Chute and rainwater pipe 28.1 Roof slope NR03 Repointing and mortar repairs

Revision: -
First issue
Date: 15 July 2024

OTH-PUR-TH-RF-SKE-A-3732

Page 1 of 4 - rainwater pipe recess

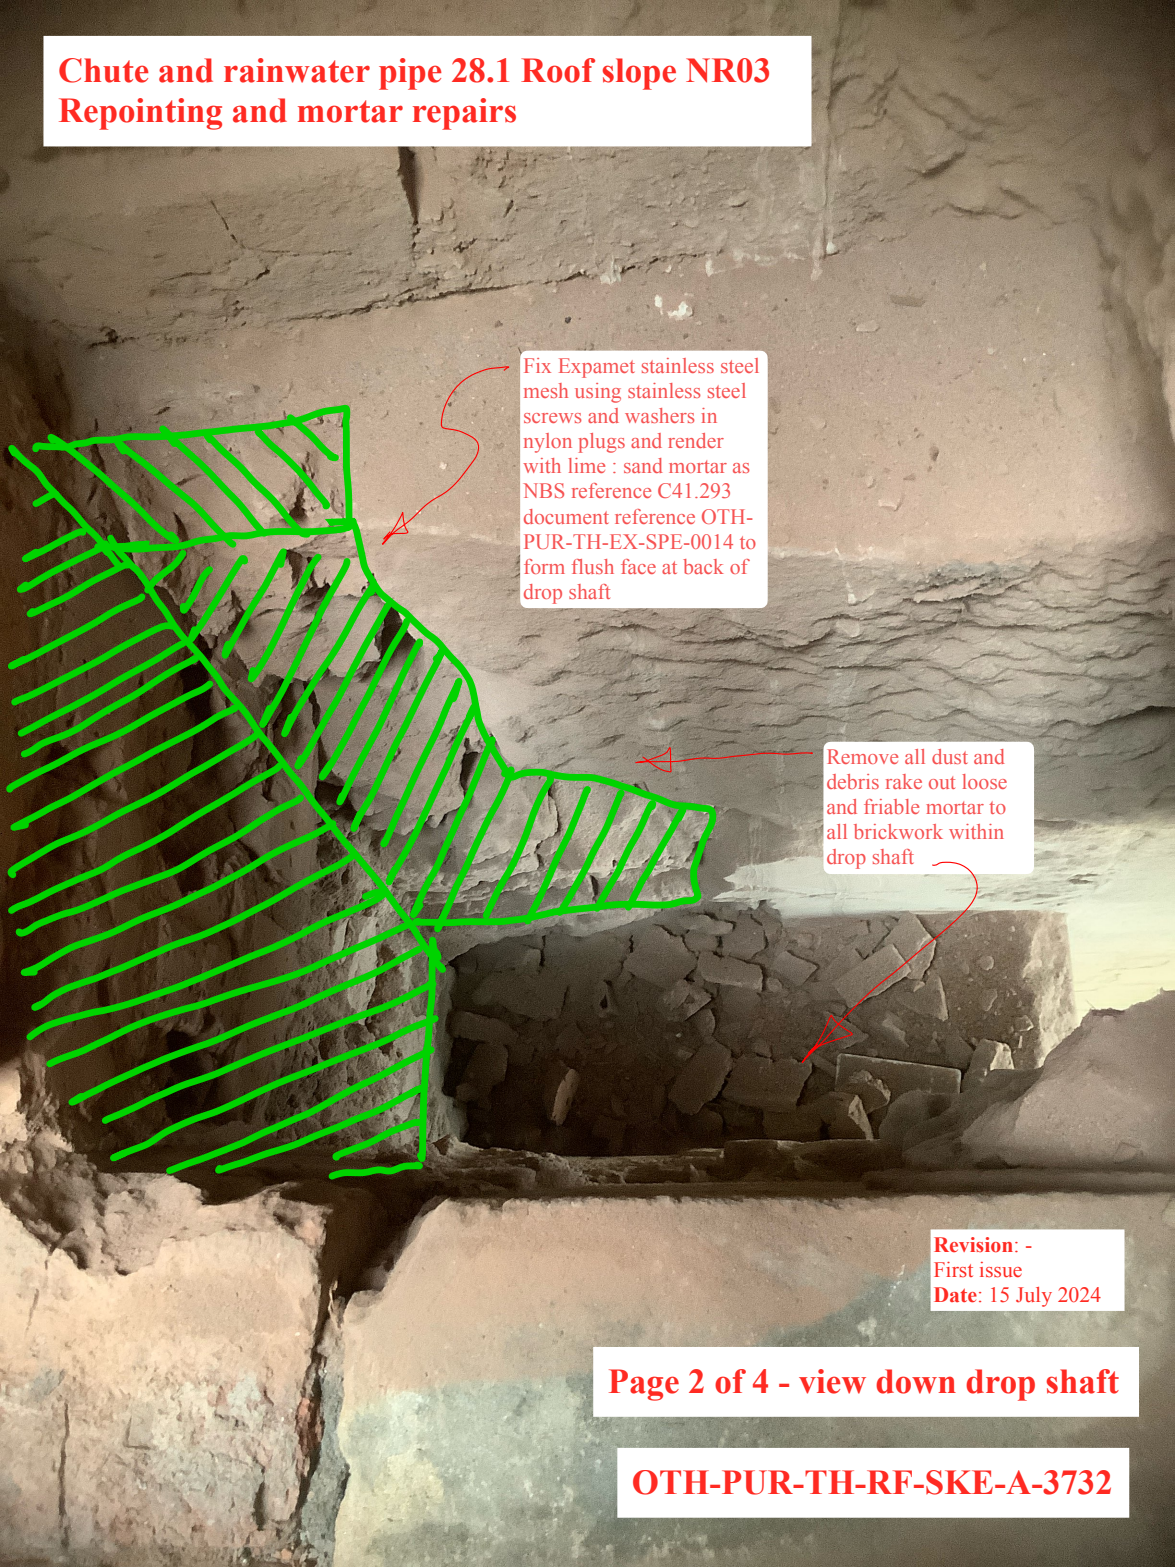
Fix Expamet stainless steel mesh using stainless steel screws and washers in nylon plugs and render with lime : sand mortar as NBS reference C41.293 document reference OTH-PUR-TH-EX-SPE-0014 to form flush face at back of drop shaft

Remove all dust and debris rake out loose and friable mortar to all brickwork within recess to minimum 25mm deep and repoint using lime :sand mortar

Page 2 of 4 - view down drop shaft

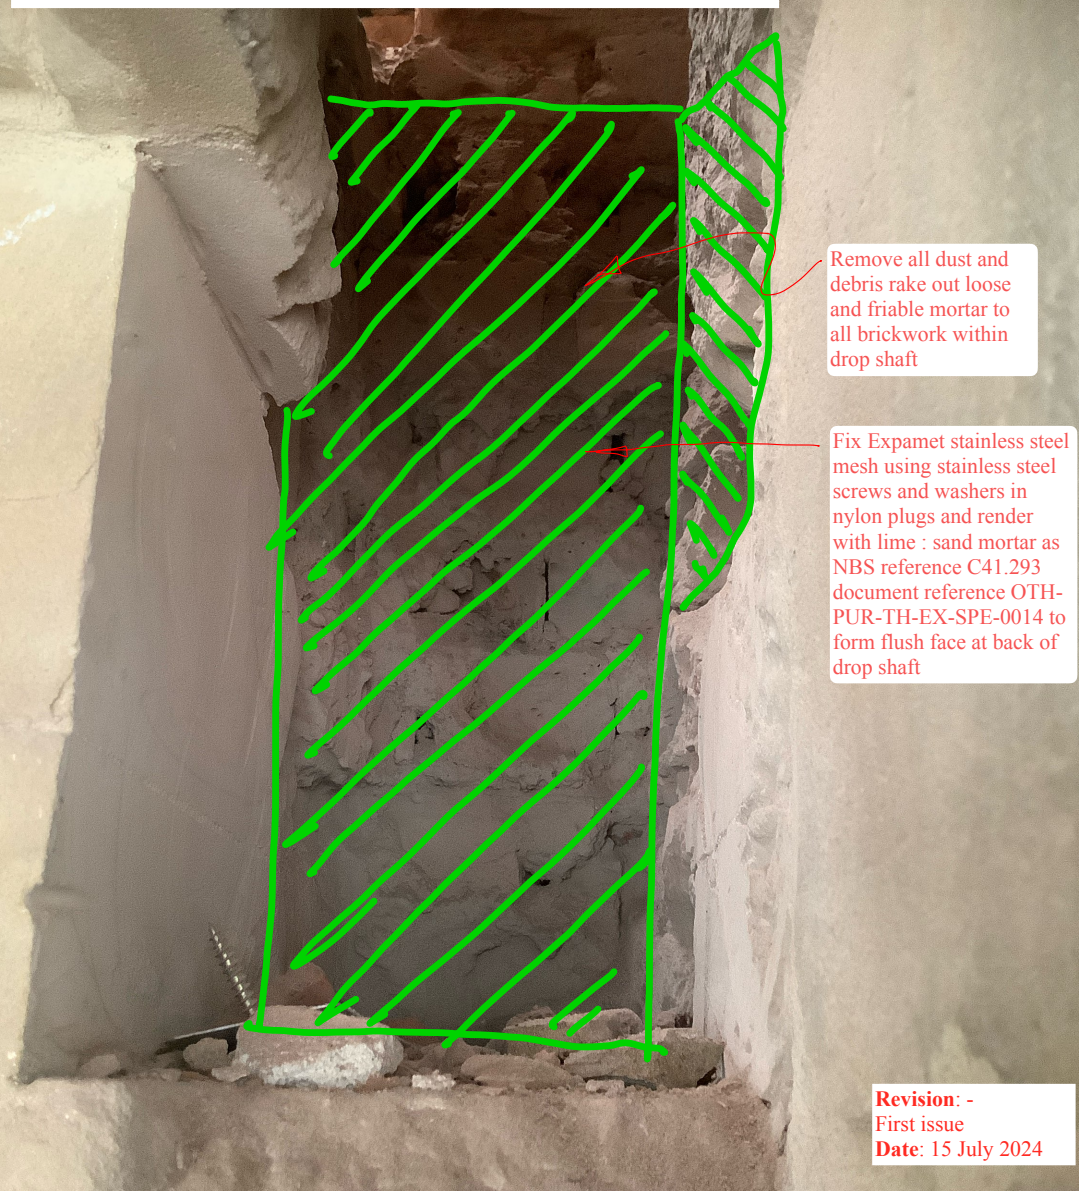
Fix Expamet stainless steel mesh using stainless steel screws and washers in nylon plugs and render with lime : sand mortar as NBS reference C41.293 document reference OTH-PUR-TH-EX-SPE-0014 to form flush face at back of drop shaft

Remove all dust and debris rake out loose and friable mortar to all brickwork within drop shaft
